# **Fixing MACT -- The LMWC Rule**

### **3 Major Problems with The LMWC Rule**

## CAA says “average” but EPA uses “UPL”

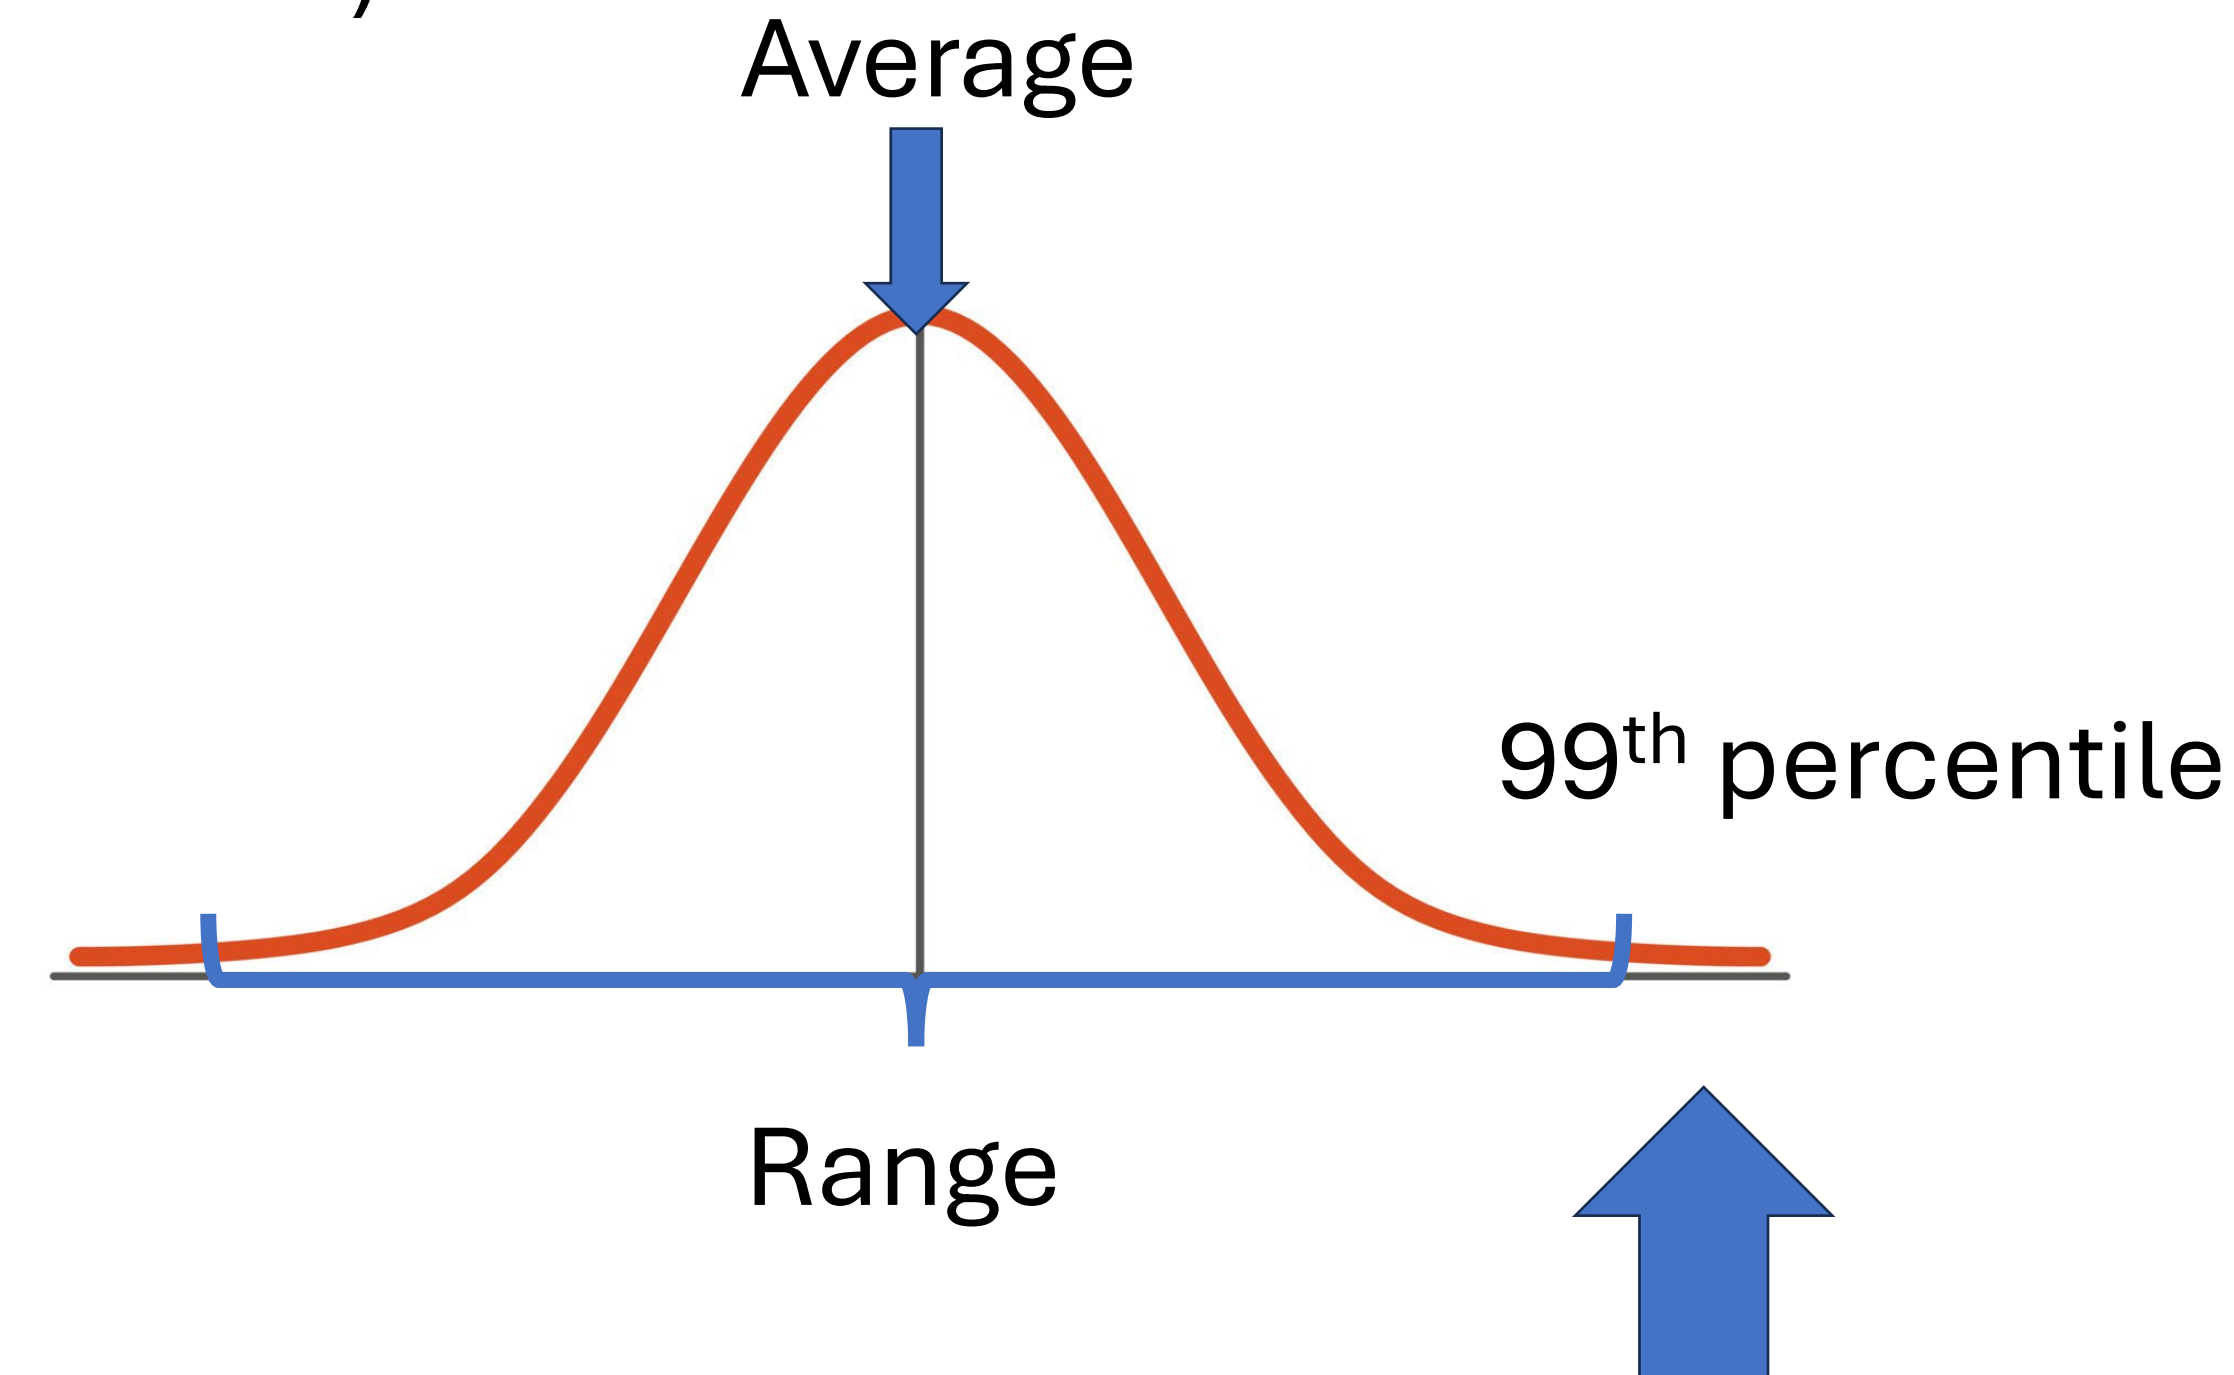
EPA instead uses UPL formula to calculate the floors,  
always resulting in floors higher than the average

- EPA's UPL formula always results in higher (weaker) floors

From within that range, EPA always chooses the highest (weakest) emission floor possible.

- EPA should abandon the UPL where it has actual performance data spanning more than a decade for individual units.
- If EPA's choice of UPL strays far from the "average of top 12%," EPA should adjust its methodology so that its result is closer to the top 12%.
- If EPA's choice of UPL percentile would result in negative emissions at the equivalent LPL percentile, EPA should lower the UPL percentile to avoid this.

## EPA's choice of upper 99<sup>th</sup> percentile produces results that are not protective and inconsistent with Congressional intent

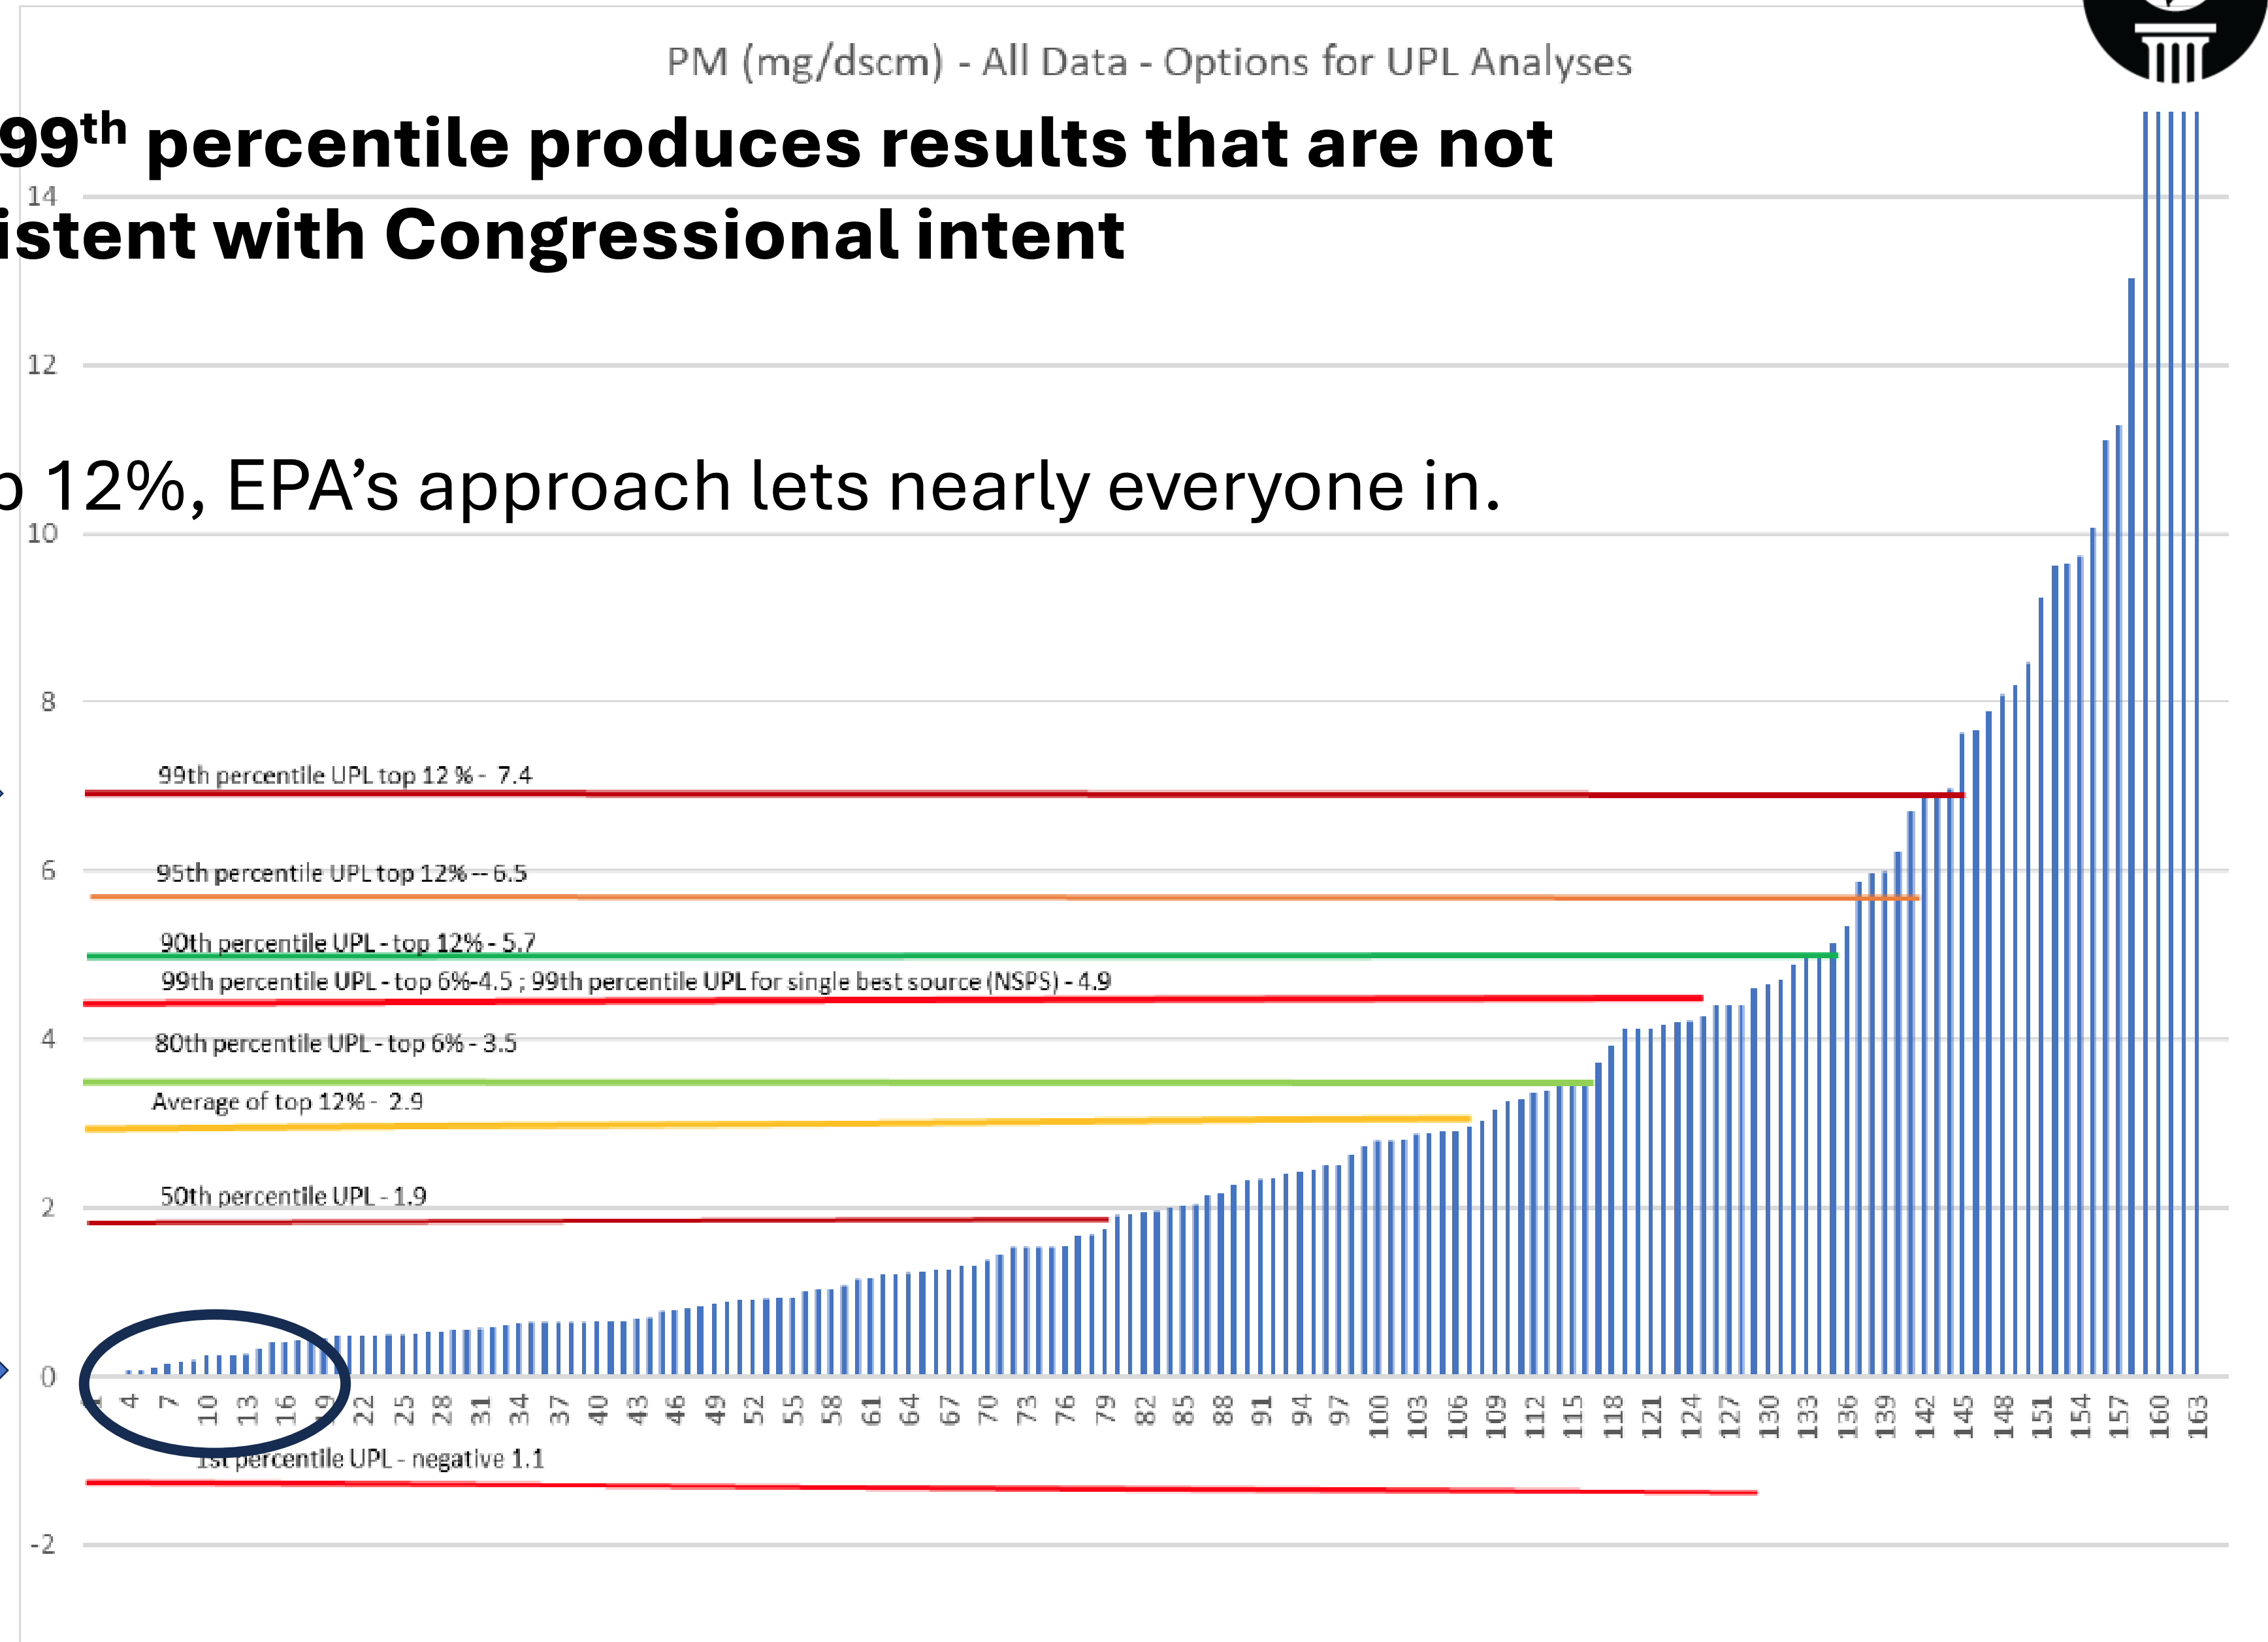
- Instead of only top 12%, EPA's approach lets nearly everyone in.

PM Proposed Rule Floor →

PM Top 12% →

# EPA's choice of the 99<sup>th</sup> percentile produces absurd results

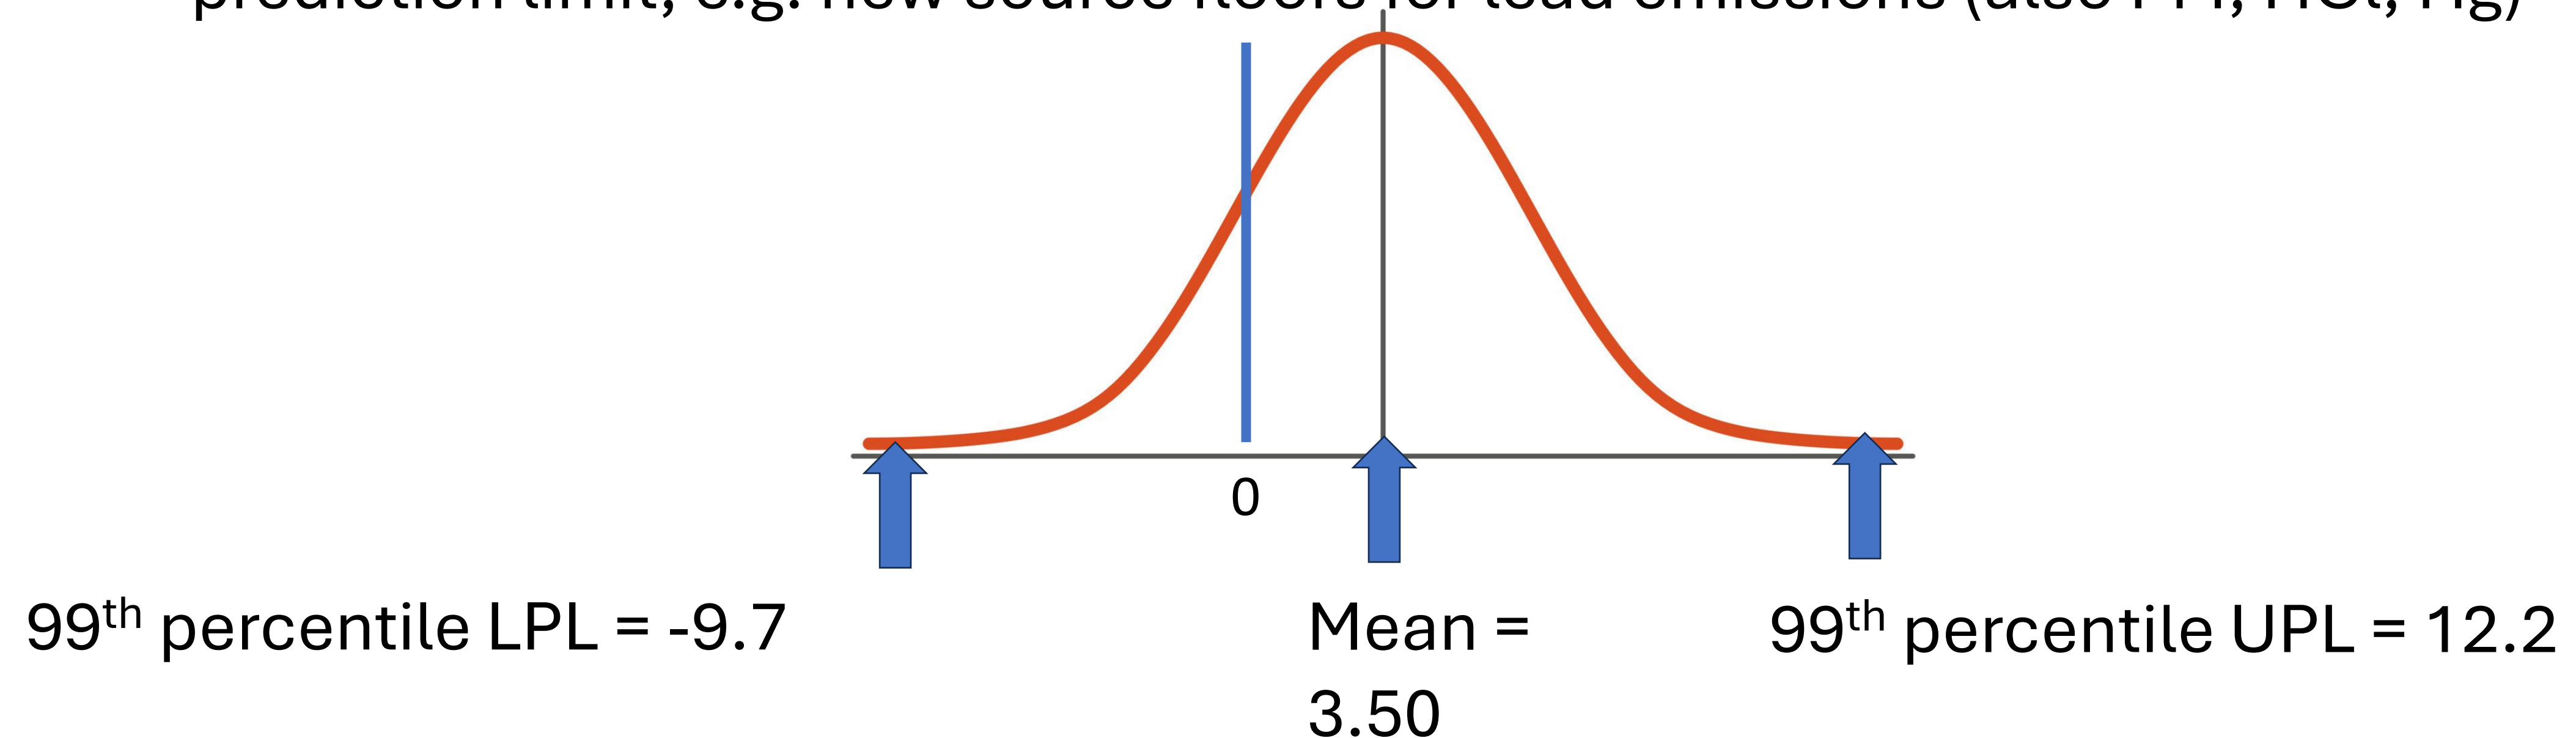
- Using 99<sup>th</sup>-percentile results in expected *negative* emissions at equivalent lower prediction limit, e.g. new source floors for lead emissions (also PM, HCl, Hg)

# Solution: EPA must ground truth its choice of UPL to avoid absurd results

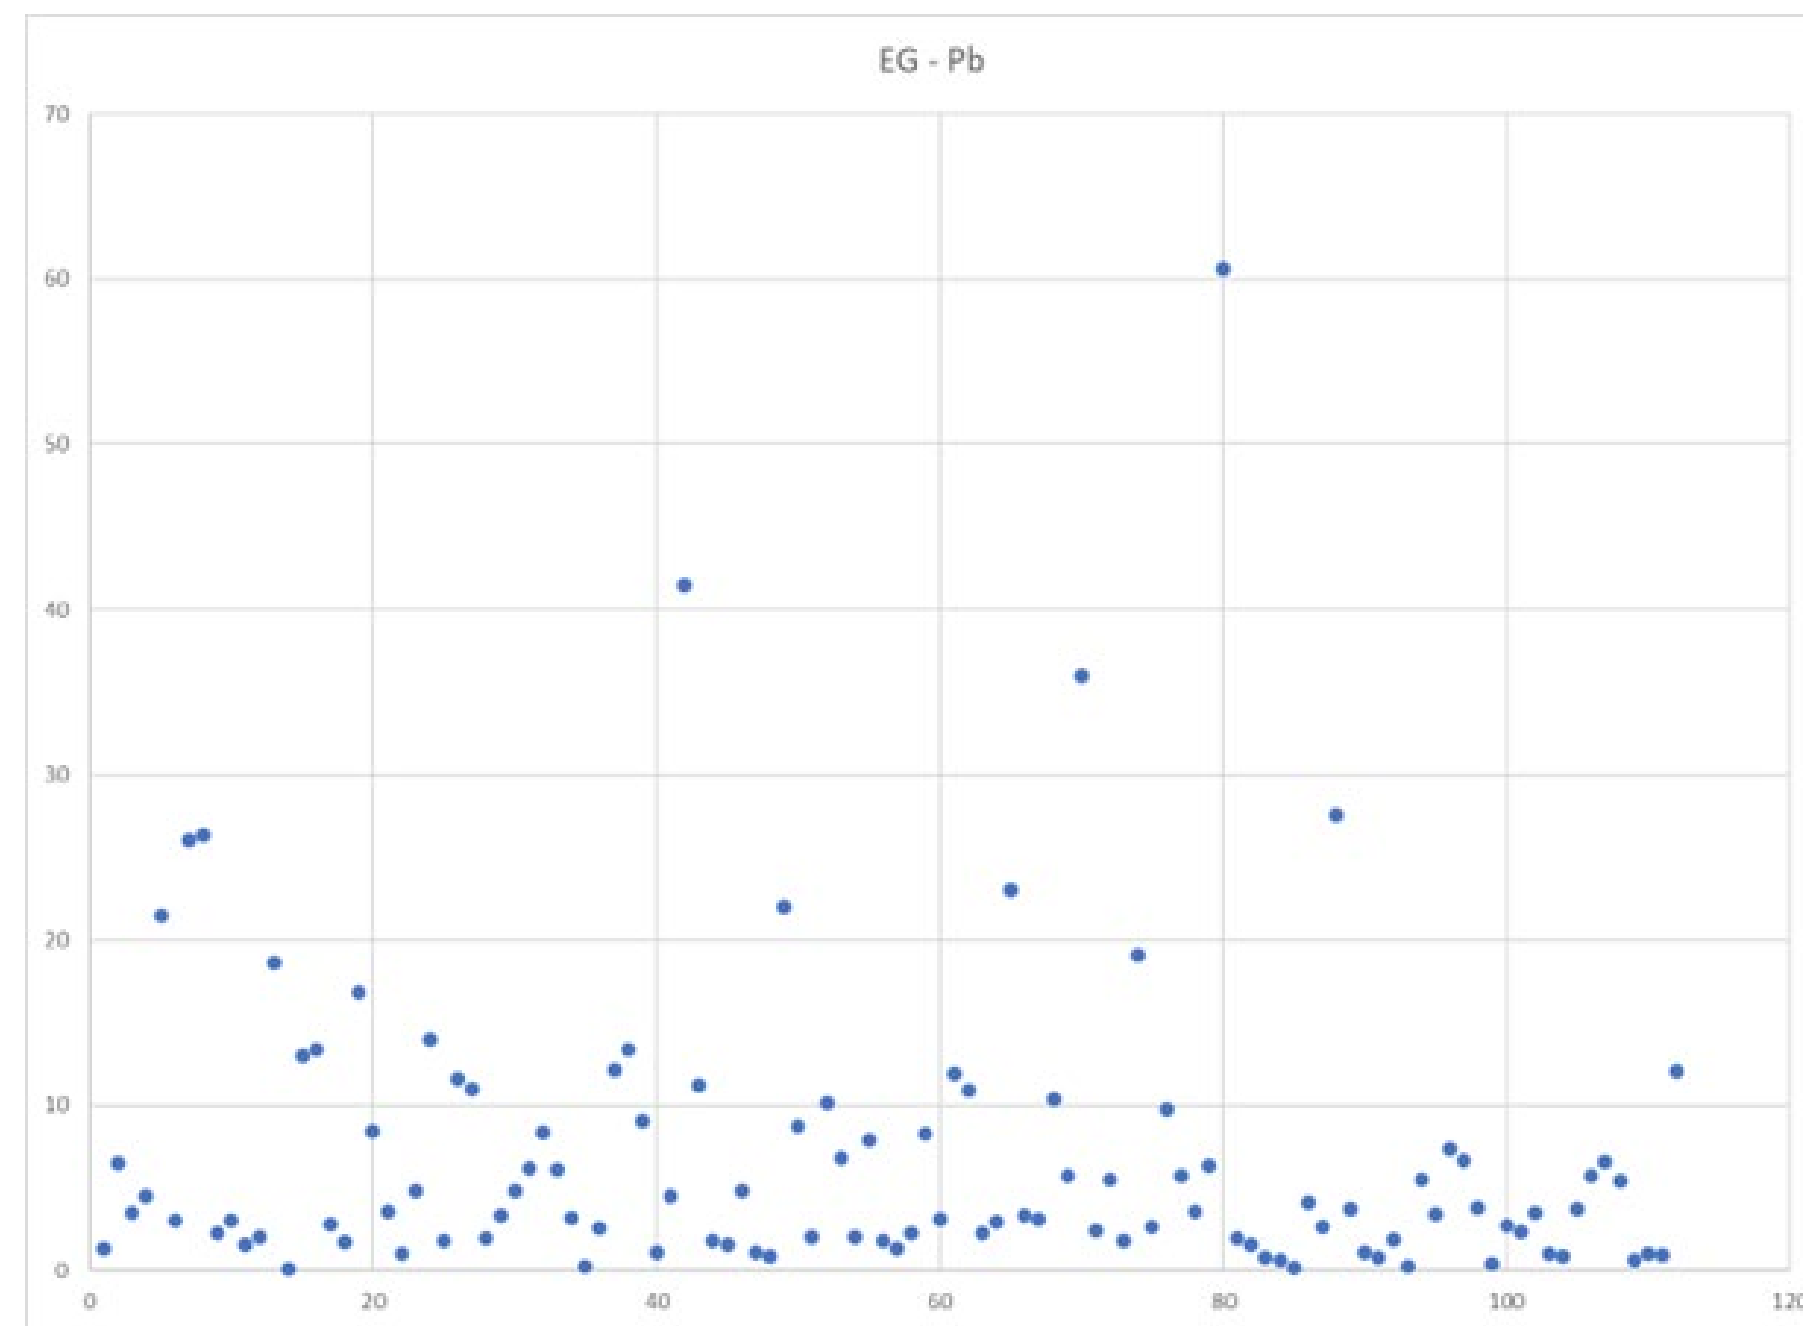
- EPA should use standard statistical tests to eliminate statistical “outliers”
